## CB-Funkgeräte AE 6490 / AE 6491

### Service Manual

**Änderungsanweisung für AE 6490/91 - falls nebeneinander stehende LKW sich nicht in AM hören können**

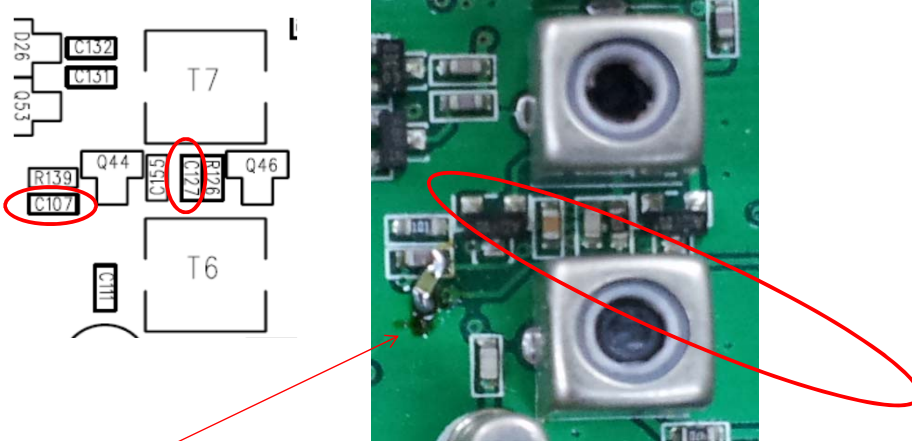
Following capacitor change can solve strong signal behaviour problems in AM

Folgende Kondensatoränderung beseitigt das bei AM Empfang feststellbare Großsignalproblem.

Description	Location	Original	Add or change - Hinzufügen
Chip Ceramic	C127	5PF	180PF
Chip Ceramic	C107	12PF	change to 6 pf or keep value as it is - auf 6 pF ändern oder Wert unverändert lassen

But The C127 position is not easy modify because The solder iron can't touch it.

So we are change of modify, Add Chip ceramic 180PF from C107 to Ground.

Da man schlecht an C 127 löten kann, ist es einfacher, 180 pF zusätzlich an gezeigter Stelle einzulöten.

**3. Measurement result.**

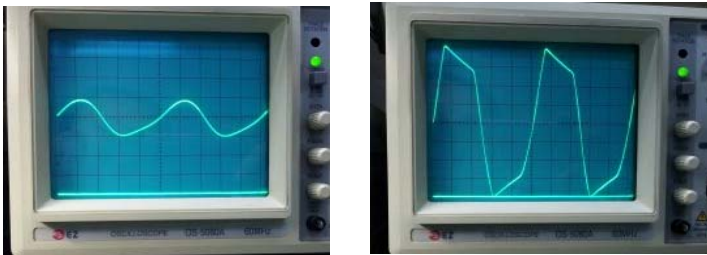
Test input condition : AM60%, RF output = 0 dBm, measurement channel frequency.

Before)

After)
